**From:** [dfn707@gmail.com](mailto:dfn707@gmail.com) on behalf of [Doug Nissen](#)  
**To:** [Sadowsky, Steve](#)  
**Cc:** [clint garwood](#)  
**Subject:** 1503 West Ave Window Question  
**Date:** Monday, August 04, 2014 4:36:40 PM  
**Attachments:** [1503 West Lower Level Floor Plan Existing.pdf](#)  
[1503 West Lower Level Floor Plan Proposed.pdf](#)

I have a question regarding the replacement of a window. Some time ago, a picture window was installed in a porch enclosure at this historic home. The window really doesn't fit with the house, so we're proposing to replace the single large window with 4 smaller ones that will match the adjacent Library windows. The overall opening width would not be affected, nor would any of the brickwork. Refer attached photos and pdfs.

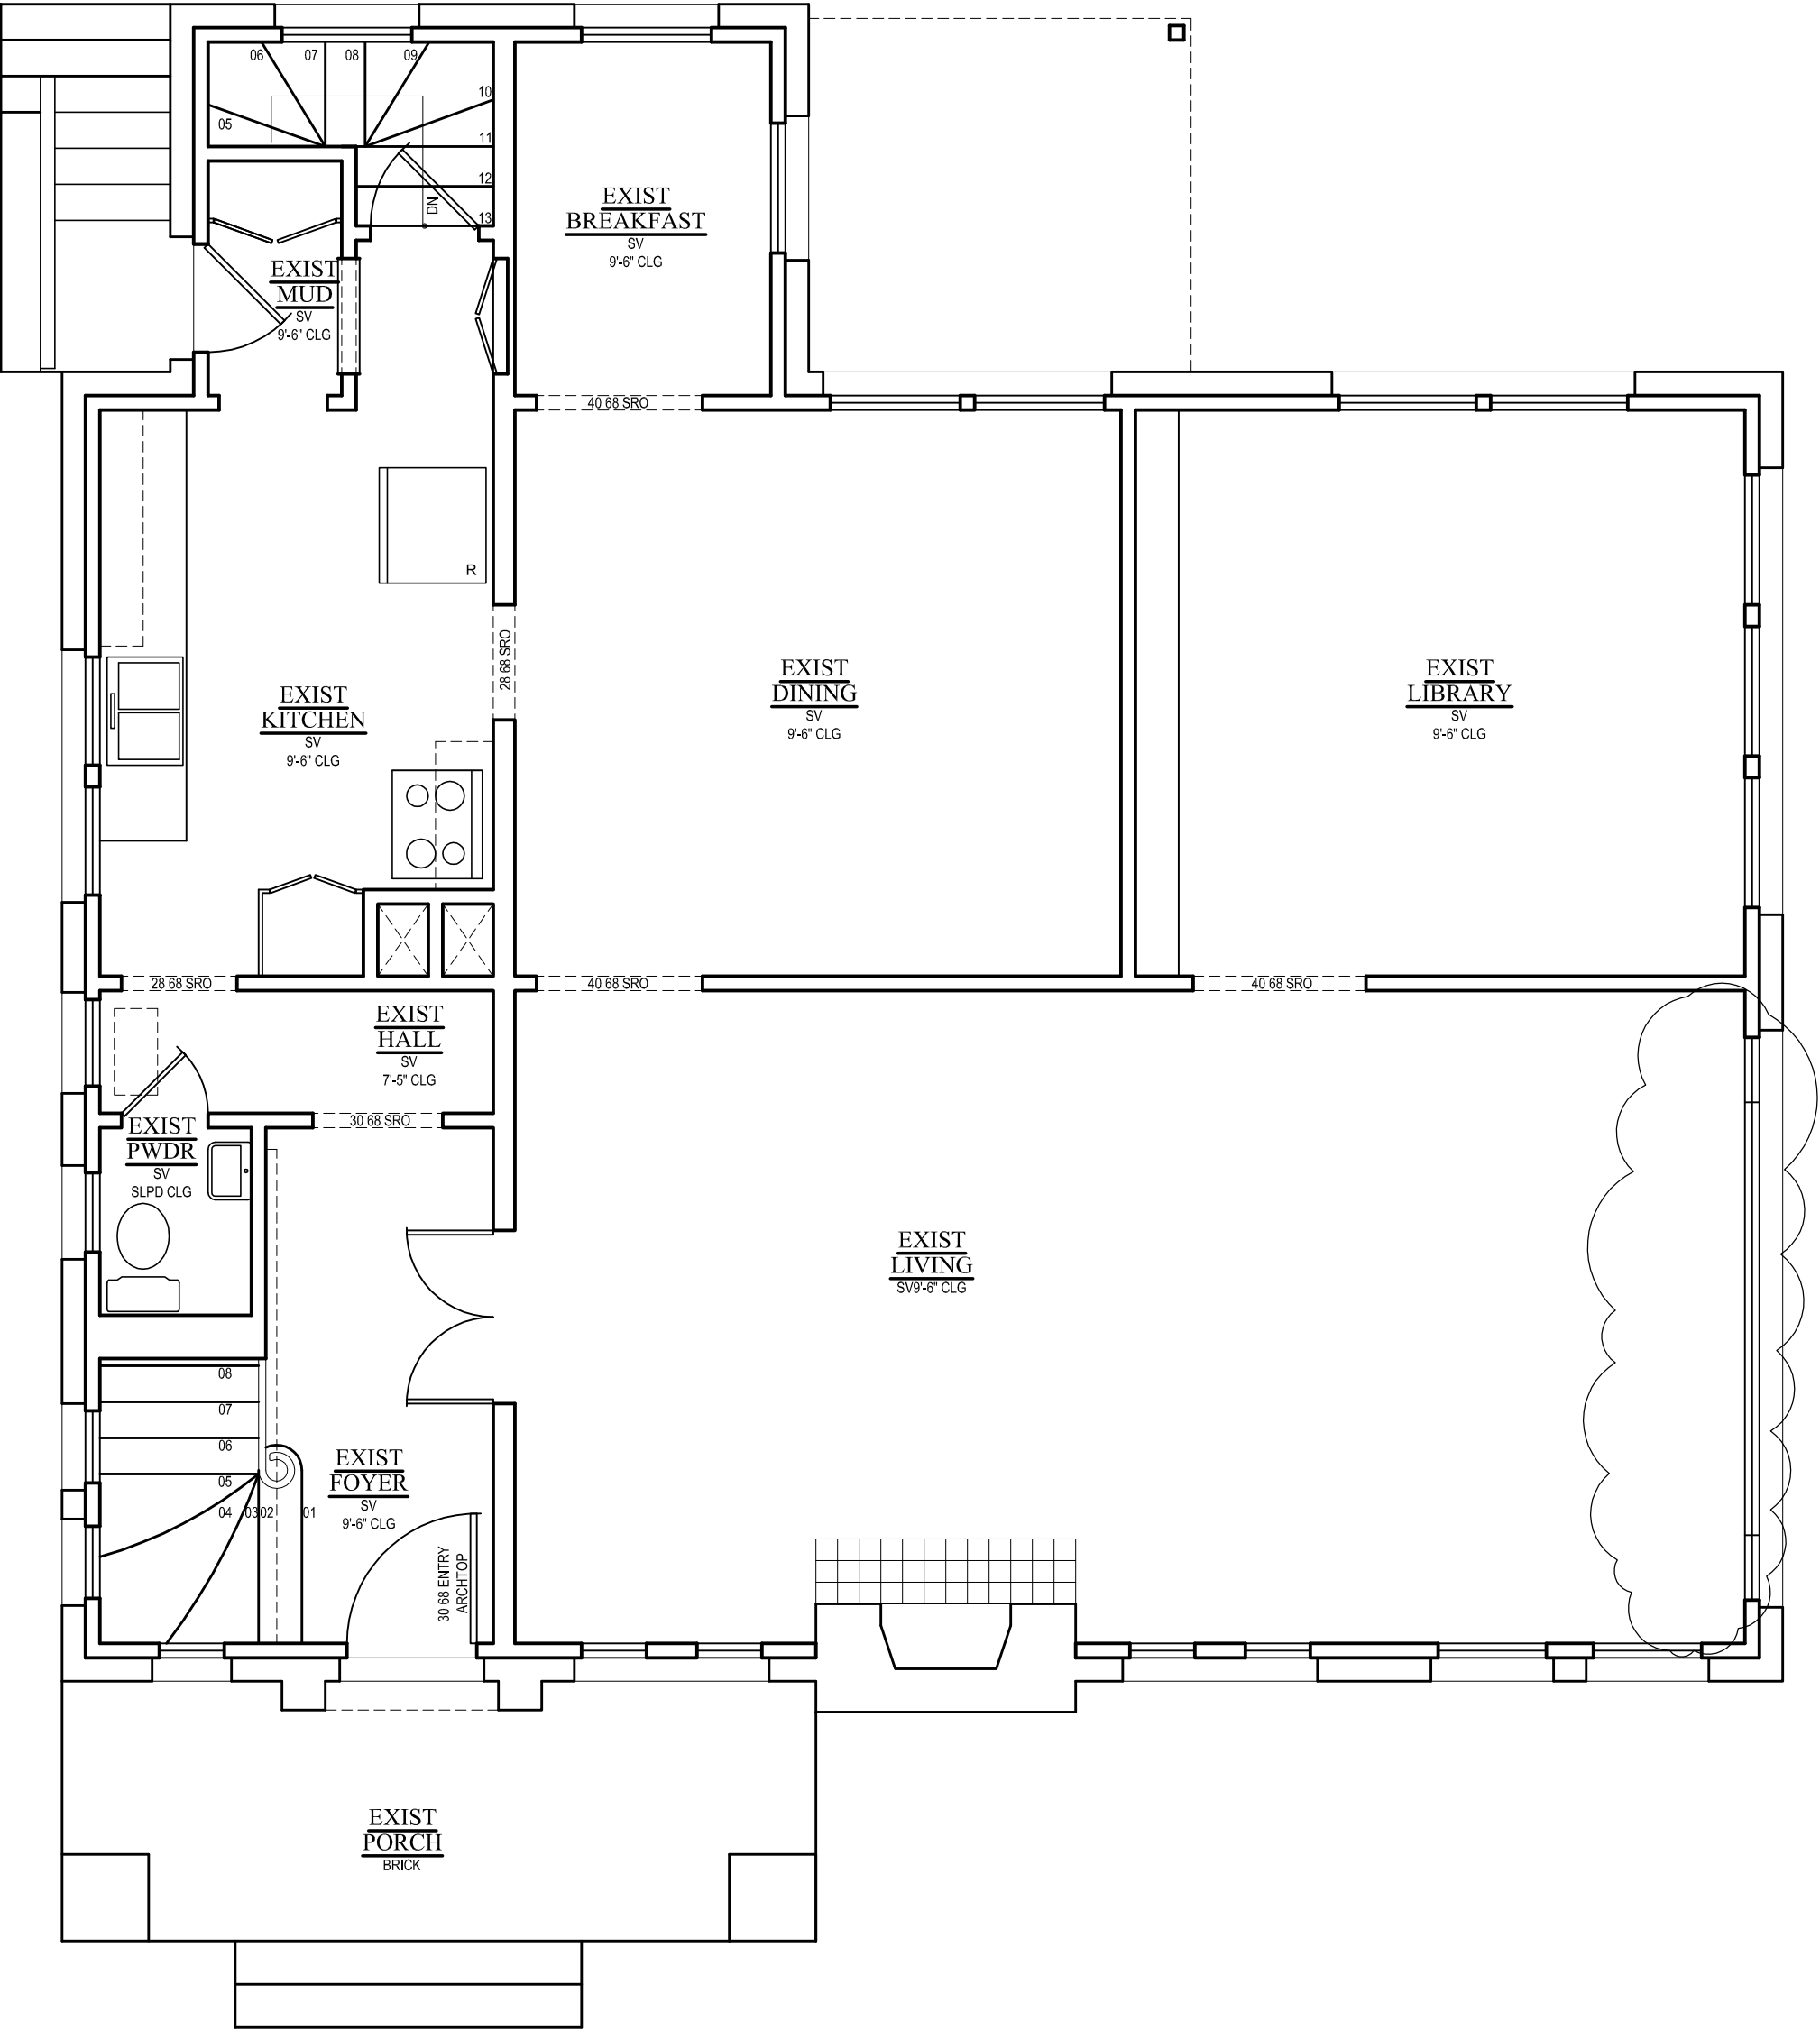
So the question is, could this proposition be granted an administrative approval?
